SB24-J-001

DTC 3243 - REPROGRAM ENGINE CONTROL MODULE (ECM)

- 2022 – 2024MY Isuzu F-Series
With a vehicle production date prior to 5/22/2024

Figure 4

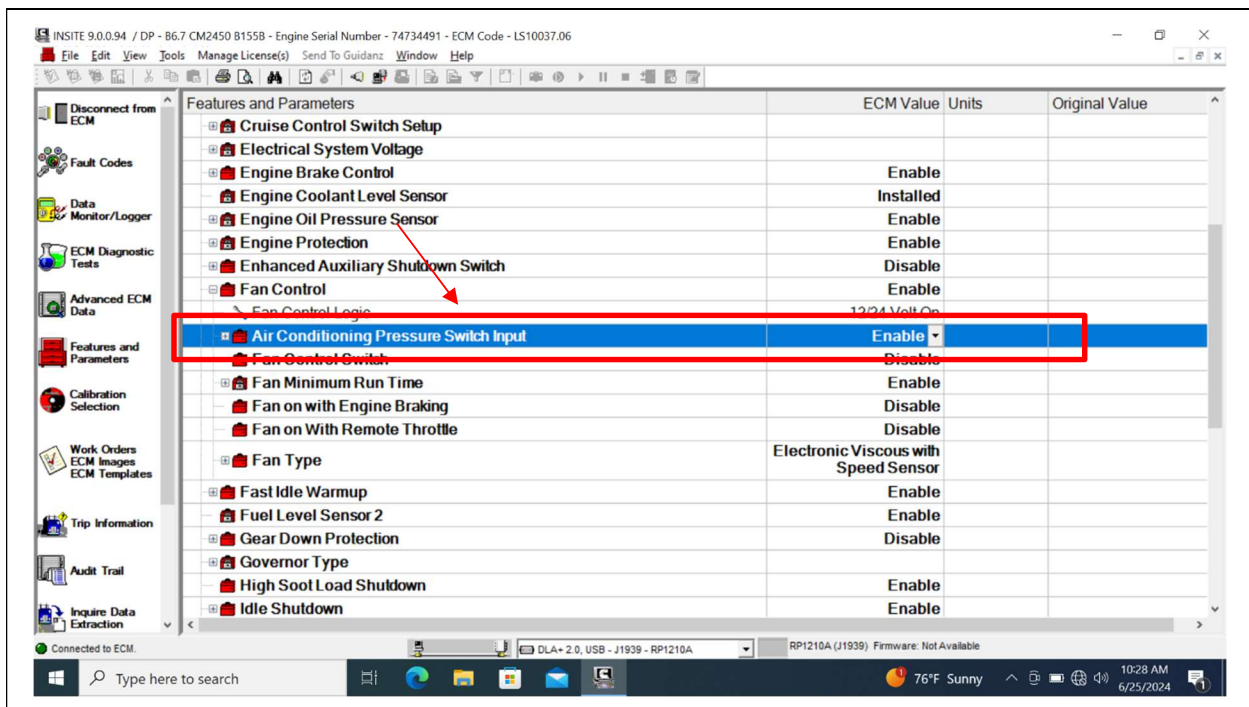
6. Select **Air Conditioning Pressure Switch Input**. (See Figure 4.)

Figure 5

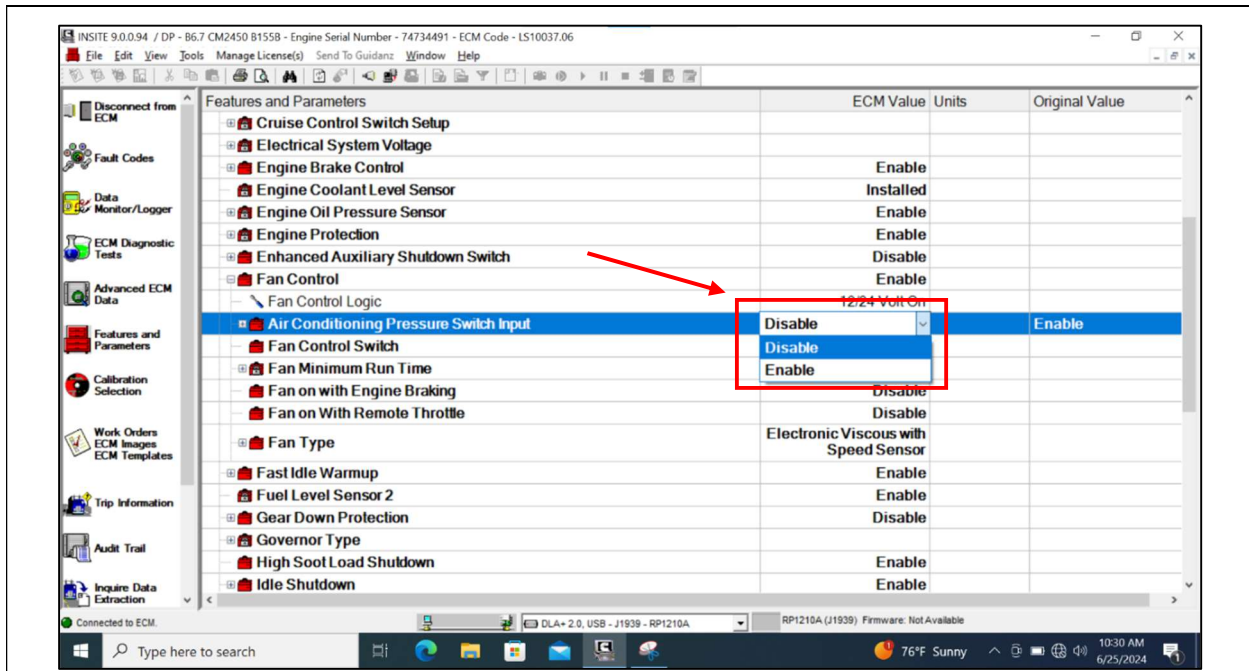
7. Select **Disable** for Air Conditioning Pressure Switch Input at the drop-down menu. (See Figure 5.)
